MODEL
2014MY
Sorento (XMa)

NUMBER
052

TECHNICAL SERVICE BULLETIN

SUBJECT: REPLACEMENT BATTERY - SERVICE INFORMATION

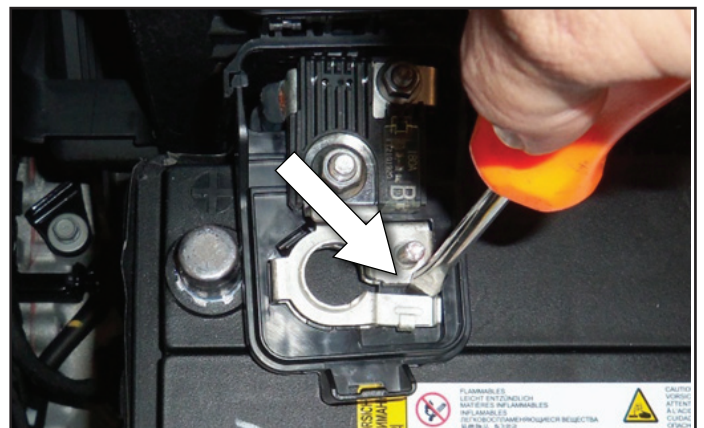
1. Install the replacement battery and insulation pad.
2. Obtain the terminal shim and use a pair of diagonal cutting pliers (dykes) to cut the shim in half and to remove the top portion, as shown below.

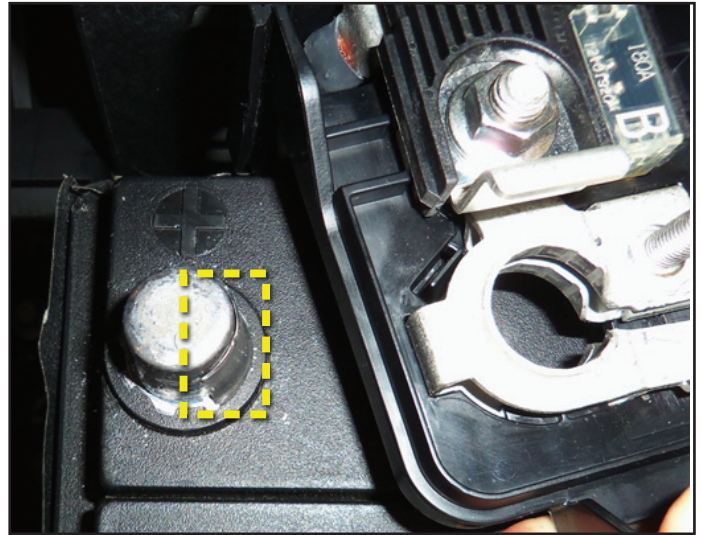
4. Use a flathead screwdriver to slightly spread open the terminal, as shown.

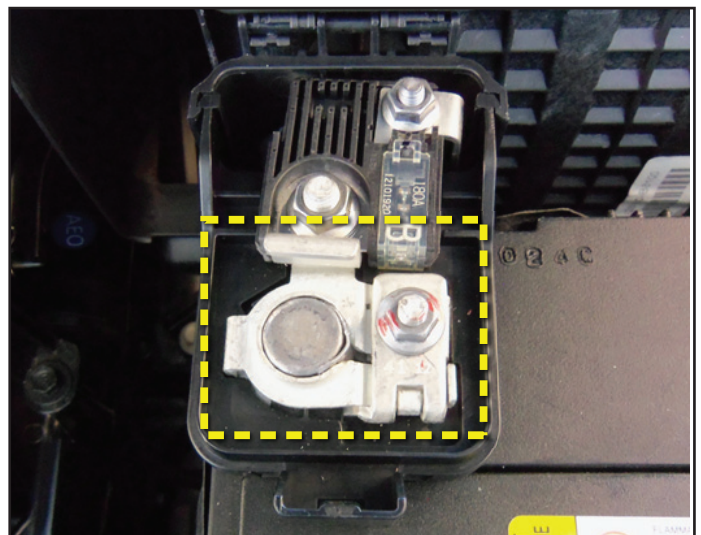
5. Install the modified shim onto the side of positive battery post. Make sure the flared portion of the shim sits flush with the base of the post and the shim is in the three o'clock position, as shown.

6. Re-install the battery terminal onto the positive battery post. Make sure the terminal is fully seated before installing the clamp and nut.

Nut tightening torque:

4.0 ~ 6.0 N.m (2.9 ~ 4.3 lb-ft)
